Access Compliance Report Public Rights-of-Way (Curb Ramps)

Main Street: HYDRANGEA_ST		Cross Street: BARBERRY_ST		Location:	NE
ADA ID: RPAT211102151157	Ramp Type:Type 1 - Perpendicular	Initial Pass/Fail: Pass	Overall Compliance: No	Severity Score:	35

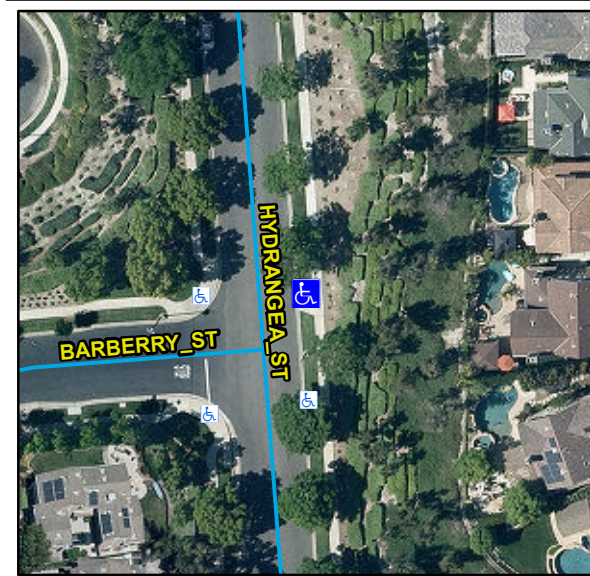
Compliance	Description	Data	Compliance	Description	Data
N/A	Ramp Length (in)	89	N/A	Flare Type LT	
Yes	Ramp Width (in)	50			Sloped
Yes	Ramp Run Slope (%)	8.2	N/A	Flare Slope LT (%)	2.4
No	Ramp Cross Slope (%)	5.5	N/A	Flare Traversable LT	No
N/A	Landing Present	Yes	N/A	Flare Type RT	
N/A	Landing Length (in)	60			Sloped
Yes	Landing Width (in)	50	N/A	Flare Slope RT (%)	17.4
Yes	Landing Run Slope (%)	1.9	N/A	Flare Traversable RT	No
No	Landing Cross Slope (%)	6	No	DWS Provided	No
N/A	Landing Movement Obstructed?	No	N/A	DWS Contrast	N/A
	Landing Movement Type	N/A	N/A	DWS Length (in)	N/A
N/A	Landing Shared	No	N/A	DWS Full Width	N/A
N/A	Clear Space	N/A	N/A	DWS Offset Left (in)	N/A
N/A	Clear Space To Crosswalk (in)	N/A	N/A	DWS Offset Right (in)	N/A
N/A	Marked Crosswalk 1	No	N/A	Marked Crosswalk 2	N/A
	Crossing 1 Direction	W		Crossing 2 Direction	N/A
	Marked Crosswalk 1 Width (in)	N/A		Marked Crosswalk 2 Width (in)	N/A

N/A	Ramp Inside Crosswalk 1	N/A	Yes	Ramp Inside Crosswalk 2	N/A
	Crossing 1 Slope (%)	1.5		Crossing 2 Slope (%)	N/A
	Crossing 1 Cross Slope (%)	6.6		Crossing 2 Cross Slope (%)	N/A
Yes	Gutter Ponding	No	No	Curb Slope	6.7
Yes	Gutter Lip Height (in)	0		Road Run Slope (%)	N/A
No	Gutter Run Slope (%)	11.2		Road Cross Slope (%)	N/A
No	Gutter Cross Slope (%)	6.5			
Yes	Overall Surface Condition: Acceptable		Yes	Perp Joint Present	Yes
	Cross Gutter Present?	No		Spandrel Present?	No
	Replace Cross Gutter?	N/A		Replace Spandrel?	N/A

Possible Solutions:
Remove & Replace Entire Ramp. Remove & Replace Gutter.

OC Std/PROW:
R304.2.2, R304.5.3, R305, R304.5.4, STD 1115
